CHASE BANK EAST TOWNE 4520 East Towne Boulevard

Exterior Building Modifications to an Existing Building in Urban Design District 5

PRESENTED TO UDC ON 11/20

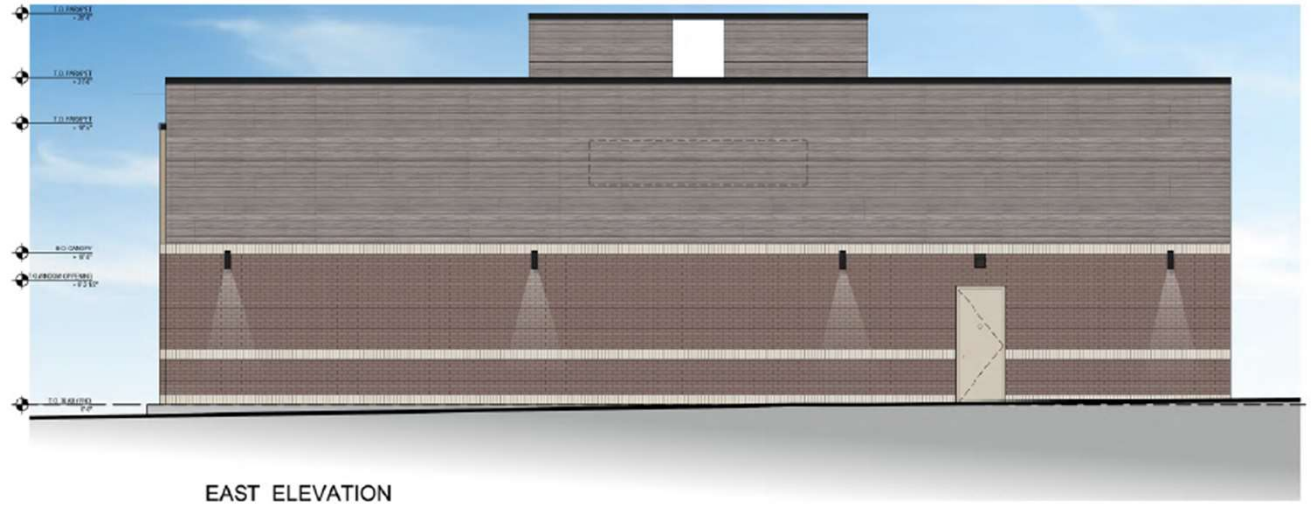
NEW PROPOSED CHANGES:

- 2 PARAPET HEIGHTS INSTEAD OF 3.
- TOWER PARAPET HEIGHTS FROM 25'-8" TO 22'-8".
- LOWER PARAPET HEIGHT FROM 18'-5" TO 17'-8".
- NEW TOP EIF'S BAND RESEMBLING TO THE SOLDIER COURSE BAND FOR UNIFORMITY ACROSS THE BUILDIGN DESIGN.
- A THICKET COPPING CAP TO EMPHAZISE THE "BASE-MIDDLE-TOP" ARCHITECTURE.
- MIRRORRED ENTRY TOWER TO BACK OF HOUSE FAÇADE TO SCREEN PROPOSED VRF EQUIPMENT ON ROOF.
- SCREENIGN AT GRADE TO COVER EXISTING ELECTRIC EQUIPMENT.

SOUTH LANDSCAPE ELEVATION

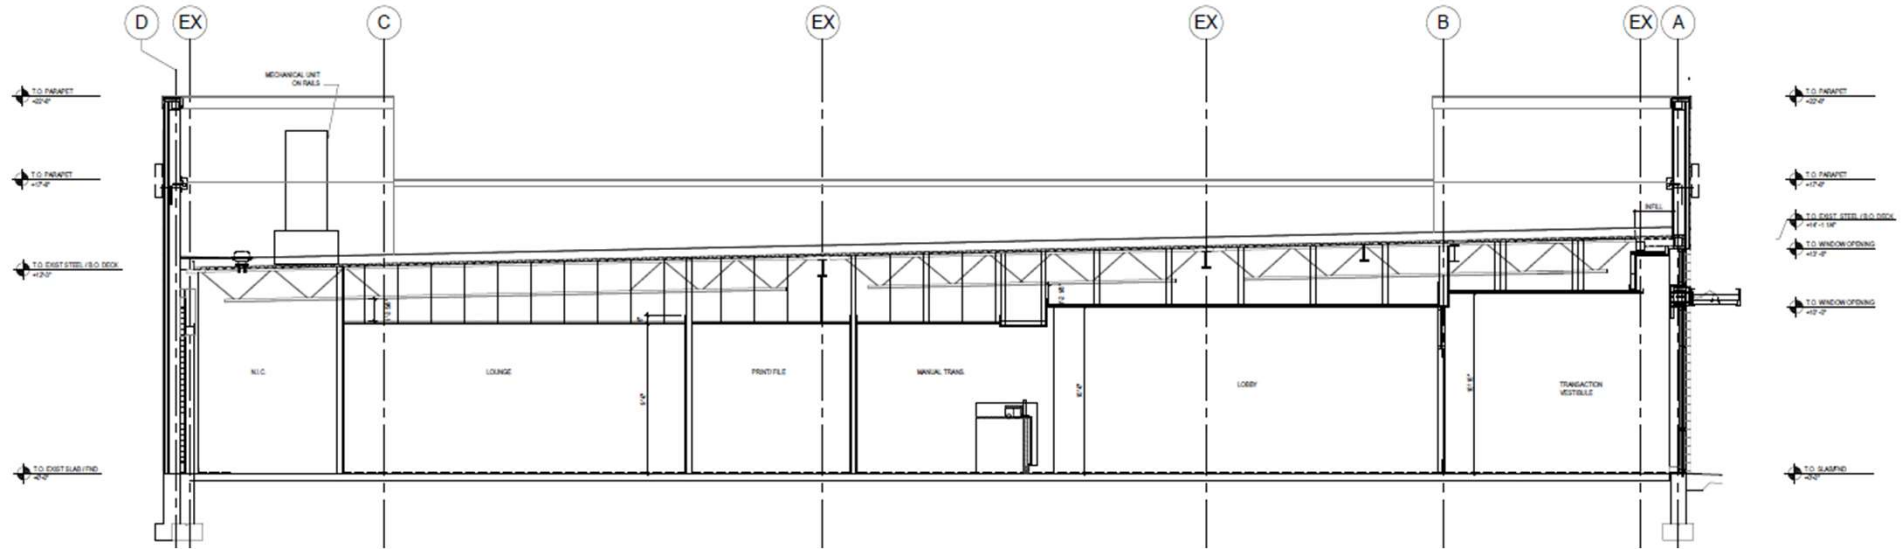
UDC COMMENT: Minimize/screen the blank walls on the south and north elevations, including landscape and architectural design elements.

RESPONSE: The concern has been addressed with a “Base-Middle-Top” design, a combination two different parapet heights. To screen the mechanical equipment at the roof, the entry tower volume has been mirrored to the back of house façade (east façade) providing symmetry and breaking the monotony of the cladding materials on the back façade which is visible from E Washington Ave. In addition, new landscaping has been added to provide a better screening and a dynamic visual with the textures of the landscaping against the cladding.
